Engineering Change Notification

Product: Minitek PWR 3.0 Receptacle

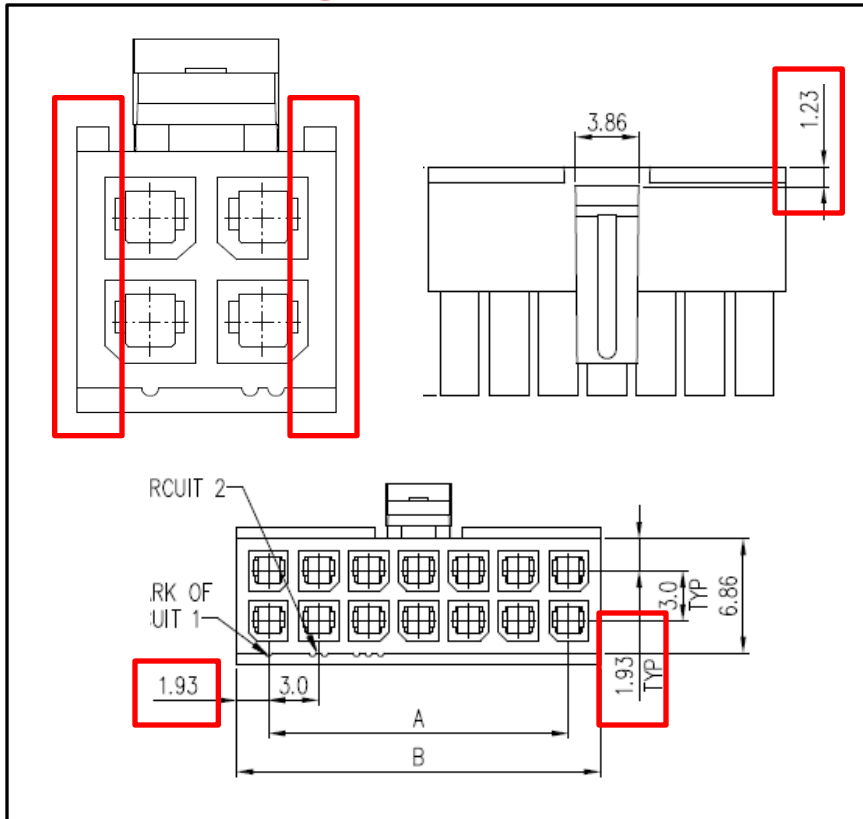
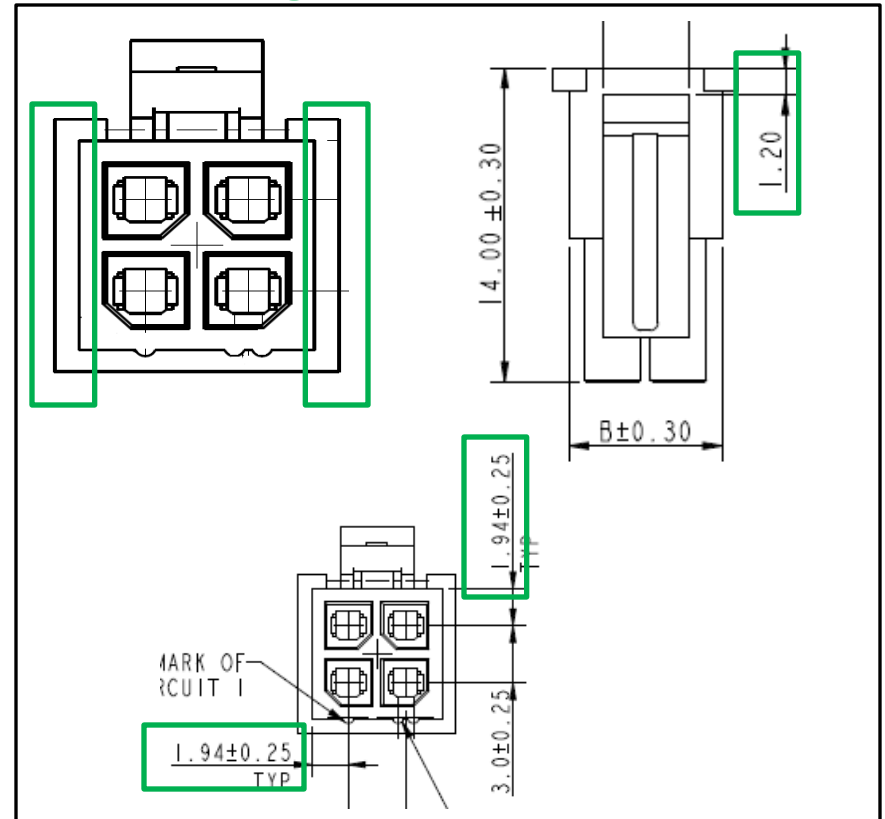
- Added removal tabs on side of the Receptacle Crimp 4 Pole housing
- Drawing Reference for 4 Pole to be changed from 10127716 to 10127716-COK

Product: Minitek PWR 3.0 Header

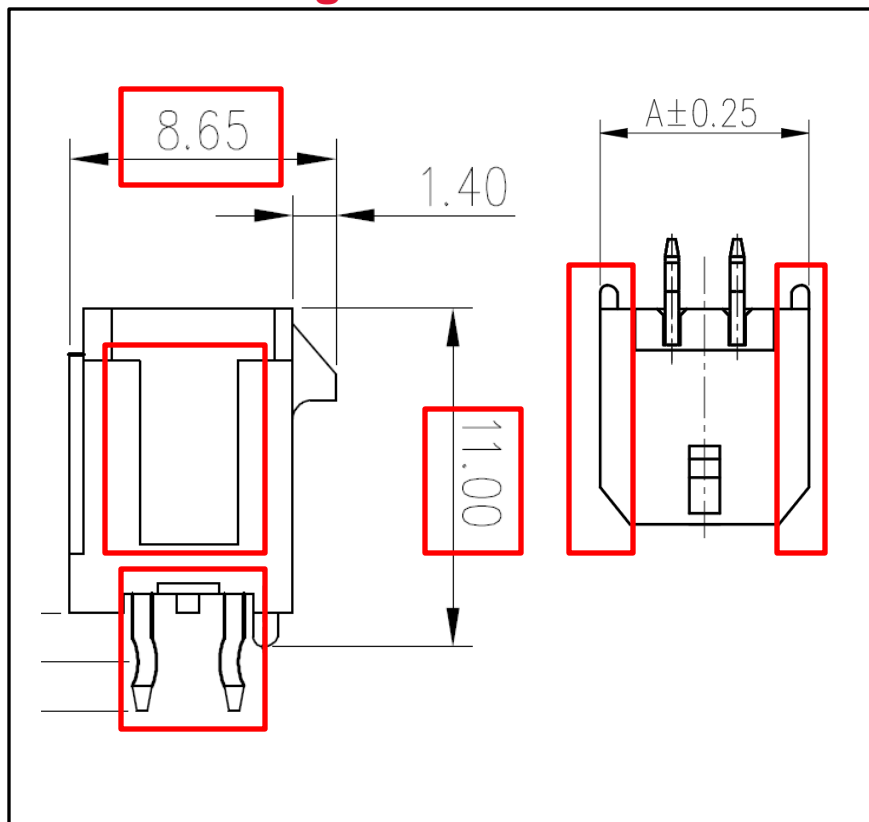
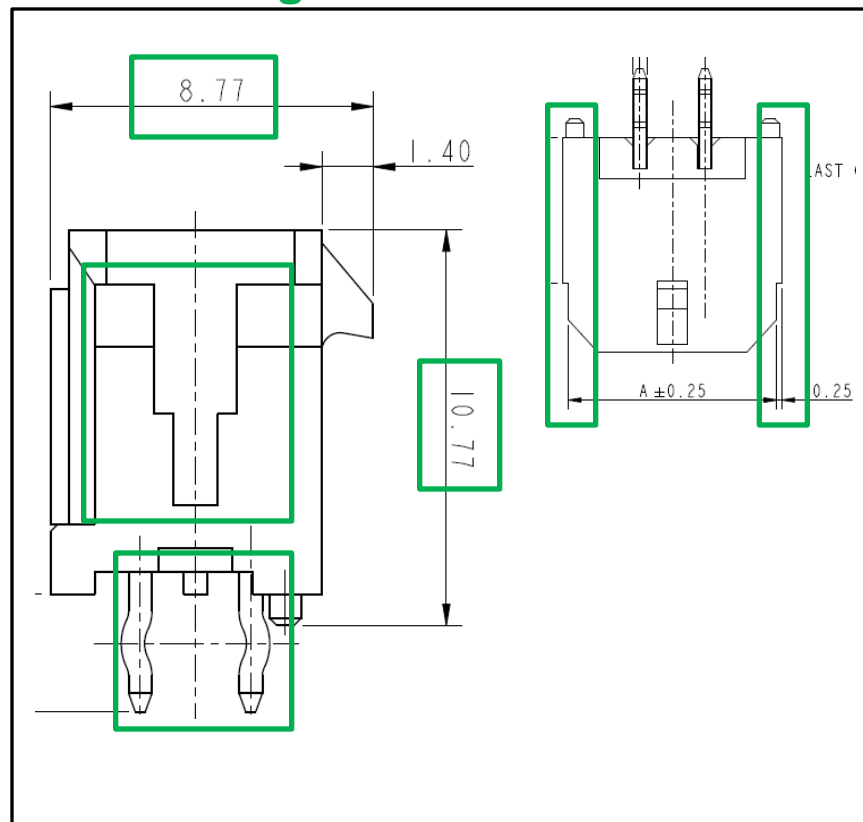
- Termination Kinking & Housing Profile Change
- Minor Dimension Changes
- Drawing Reference for 4 Pole to be changed from 10127721 to 10127721-COK

Product: Minitek PWR 3.0 Header

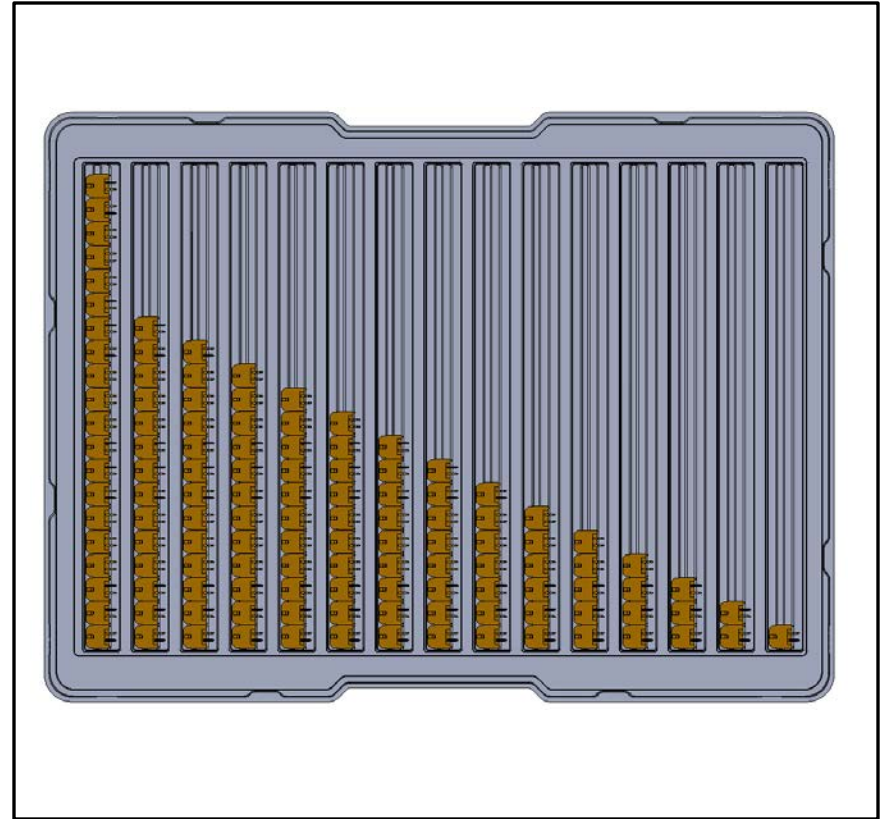
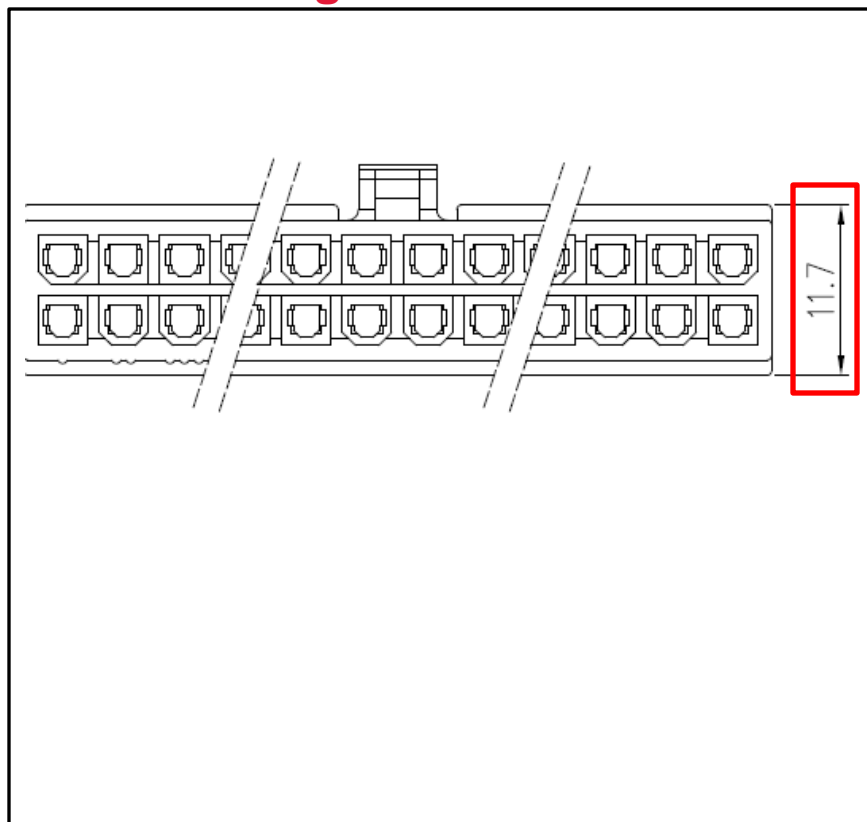
Description of Change: ➤ Tray Change → Pack Quantity for 4 Pole in Tray changed from 1845 pcs/box to 1800 pcs/box

Product: Minitek PWR 4.2 Receptacle

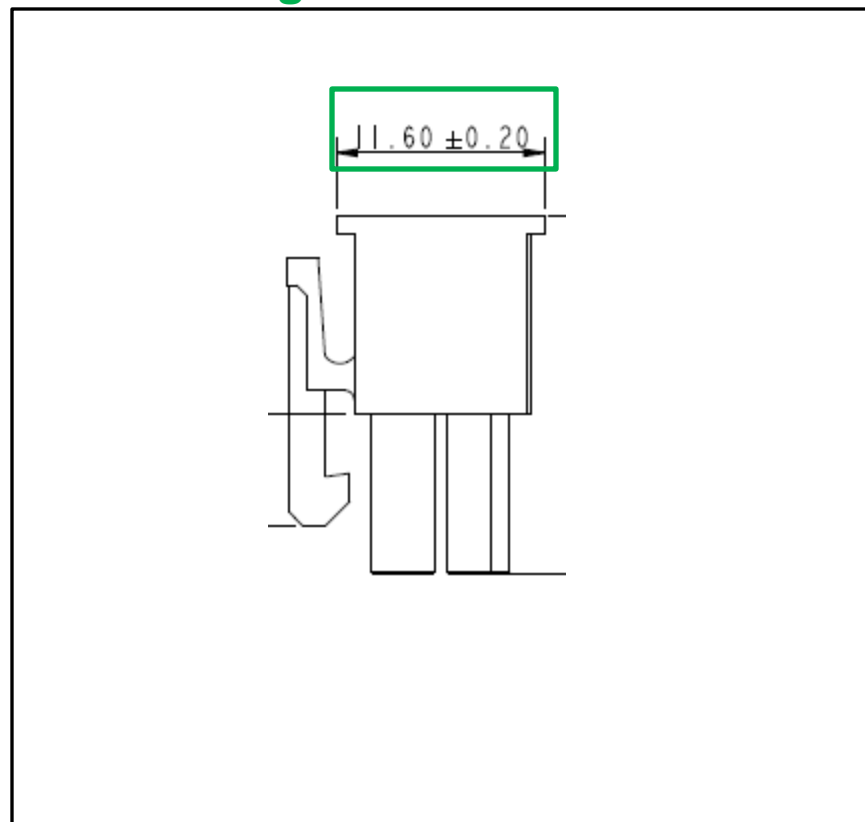
- Minor Dimensional Change
- Drawing Reference for 2 & 4 Pole to be changed from 10127815 to 10127815-COK

Product: Minitek PWR 4.2 Header

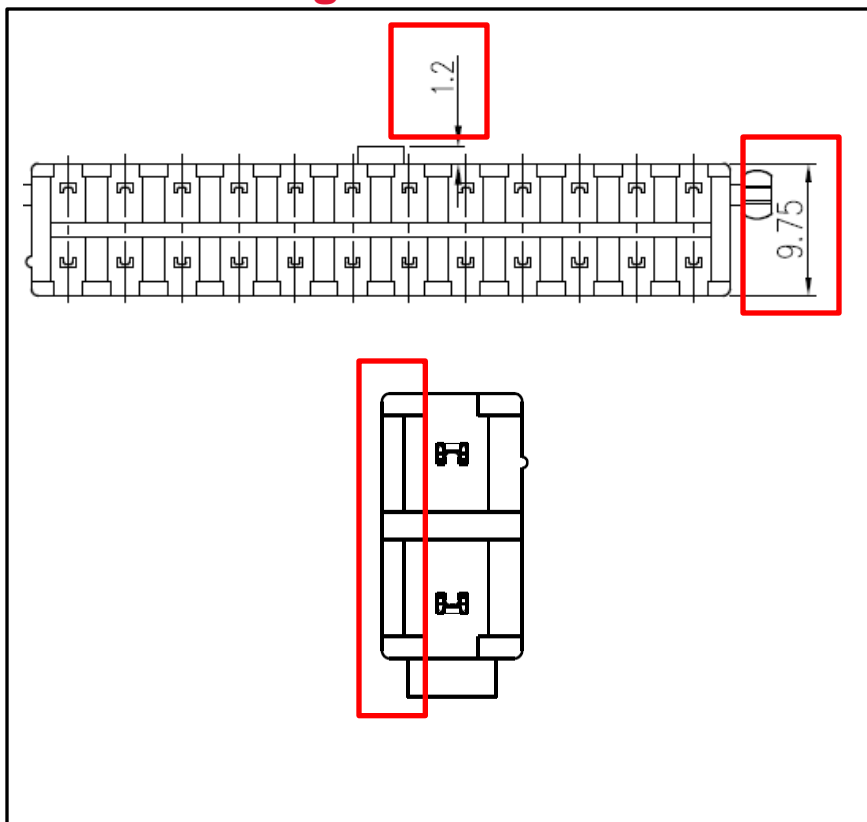
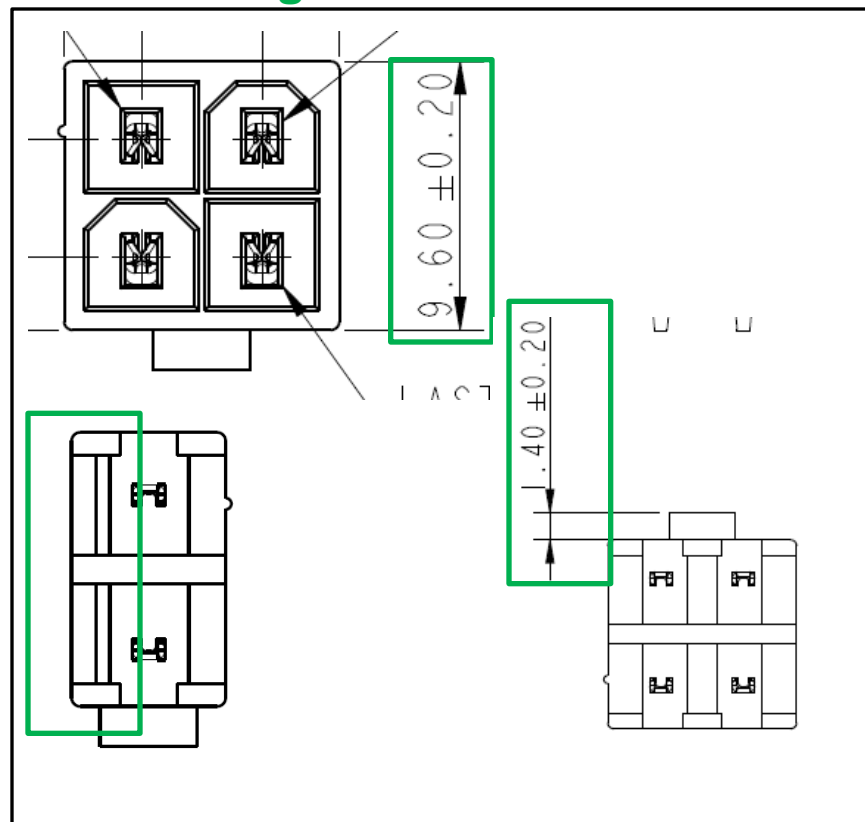
- Core-out added at Termination side of 2 Pole Connector Housing
- Minor Dimension Changes
- Drawing Reference for 2 & 4 Pole to be changed from 10127820 to 10127820-COK

Product: Minitek PWR 4.2 Header

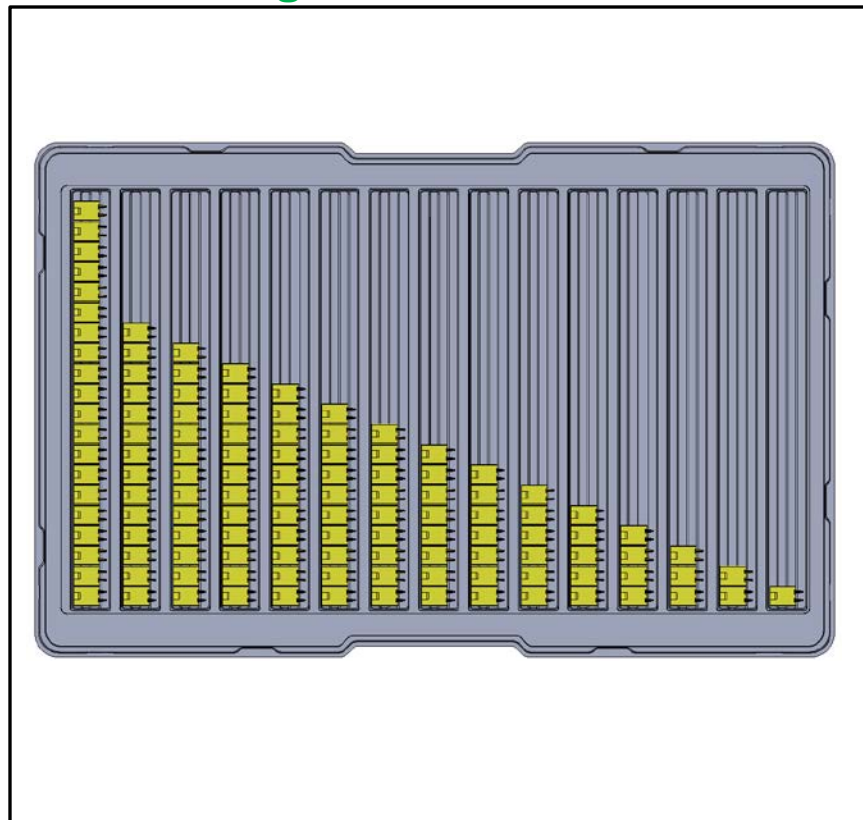
Description of Change: ➤ Tray Change → No Pack quantity change
